# PLANNING BOARD REPORT PORTLAND, MAINE

Residential townhouse - 6 unit condominium  
133 York Street  
Level III Site Plan and Subdivision  
Project ID 2013-187  
133 York, LLC, Applicant

Submitted to: Portland Planning Board Public Hearing Date: November 12 <sup>th</sup> , 2013	Prepared by: Jean Fraser, Planner Date: November 8 <sup>th</sup> , 2013 <b>Planning Board Report # 50-13</b>
---	--

*Proposed  
Building for  
133 York St  
to the Left*

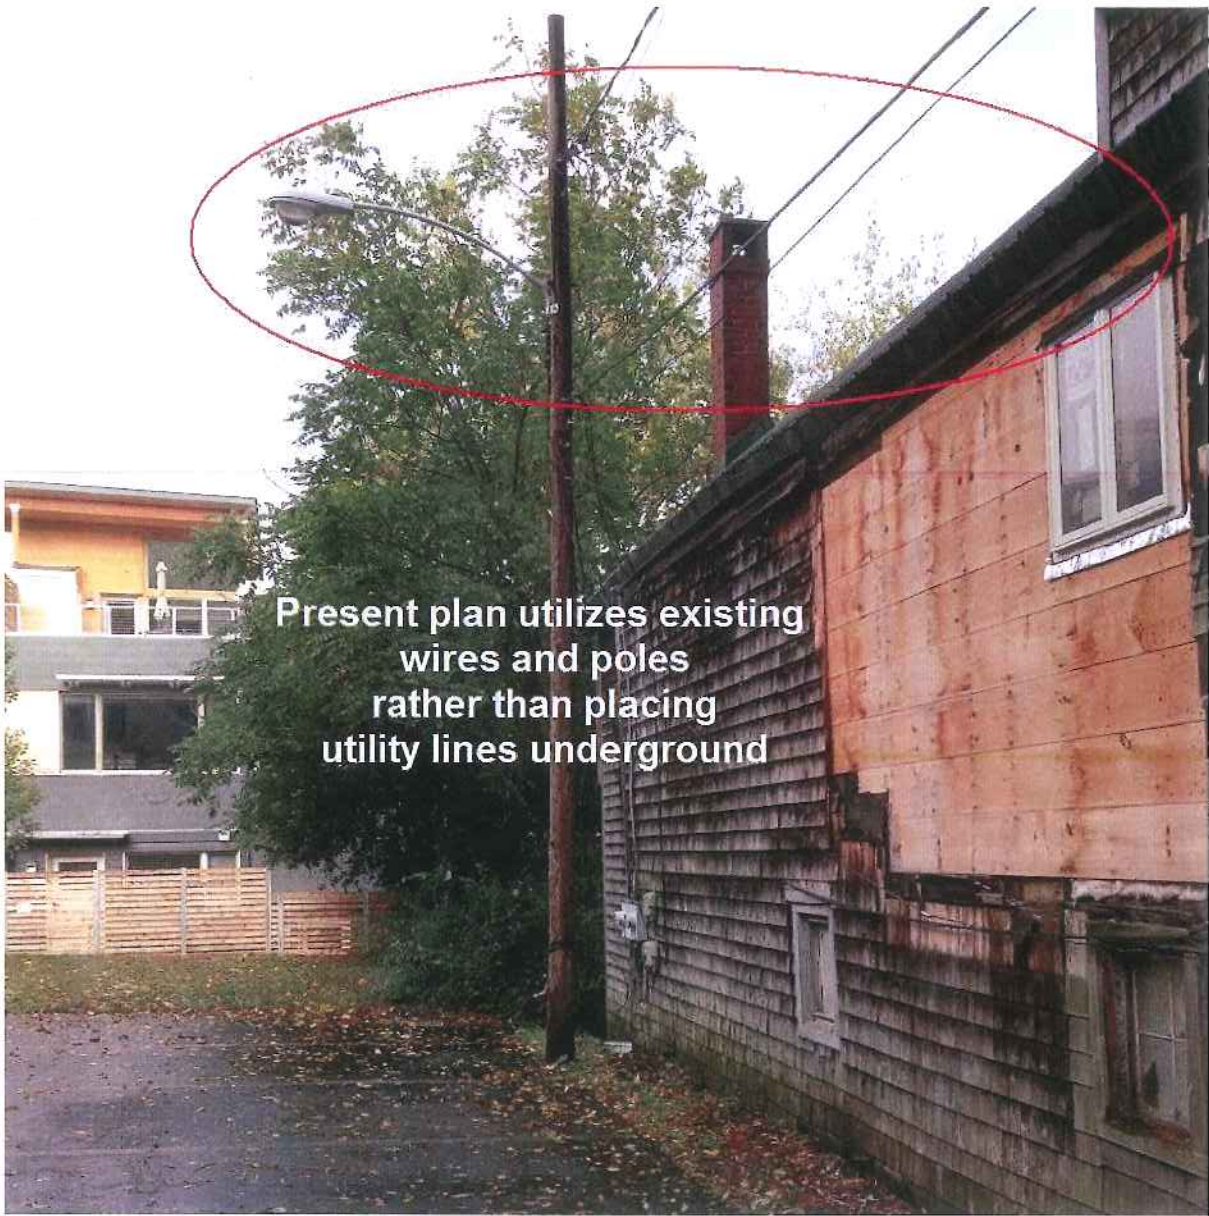
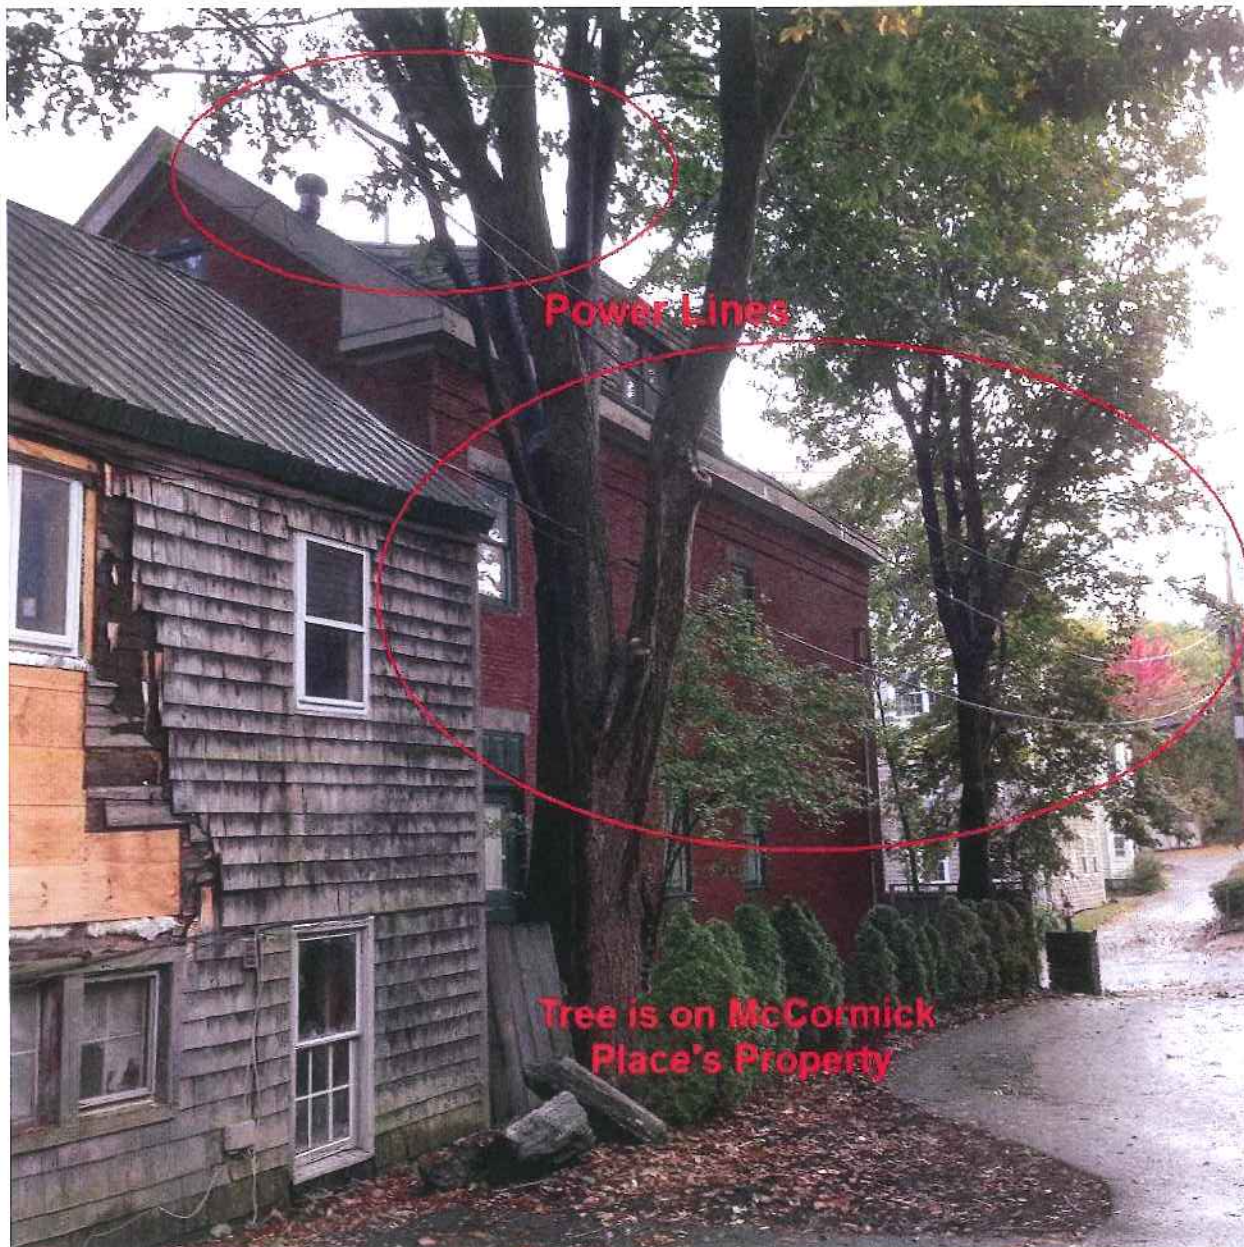
*Flat Roofed  
Buildings  
in Surrounding  
Neighborhood  
Shown Above*

**Present plan utilizes existing  
wires and poles  
rather than placing  
utility lines underground**
